**Docket:** NRC-2012-0042

Draft Regulatory Guide DG-1262 - Testing for Postquench Ductility

Subject: RIN 3150-AH42, "Performance-Based Emergency Core Cooling Systems Cladding  
Acceptance Criteria"

The Electric Power Research Institute (EPRI) is pleased to provide comments on the draft regulatory guides as published in the Federal Register on March 24, 2014.

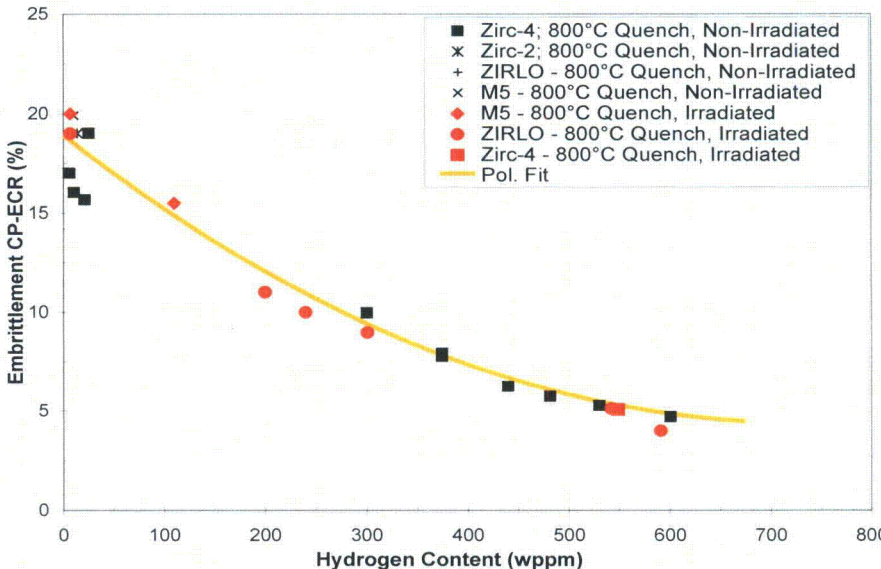
| <b>Comment</b>   | Fuel cladding fabricated from non electrolytic process source materials show consistent and stable time to breakaway oxidation. These observations do not support a concern that slight changes in the composition and manufacturing process could impact the incubation time to breakaway oxidation. Therefore, periodic testing could be removed from 50.46c and could be captured in the manufacturing qualification process.  |
| <b>Rationale</b> | <p>The bulk of the breakaway oxidation test database, which encompasses fuel cladding manufactured by different vendors/processes and spans a wide range of chemical compositions, do not show short breakaway incubation time behavior. Therefore, aside from a single occurrence of short breakaway oxidation (described below), the bulk of data do not support a need for periodic testing.</p> <p>The only instance of observed significant reduction in the incubation time to breakaway oxidation is the Russian E110 cladding manufactured from electrolytic sourced material. Subsequent testing of the alloy fabricated from non electrolytic source material, using identical tubing fabrication process, showed expected incubation time to breakaway oxidation [1]. Detailed chemical analyses of the electrolytic and non-electrolytic cladding showed significantly higher fluorine content in the electrolytic processed cladding. This is expected since fluorine containing compounds are widely used in the Russian electrolytic process as a processing material. The effect of fluorine on reducing the breakaway incubation time from surface etching is well documented in the Argonne National Laboratory (ANL) research program [2].</p> |
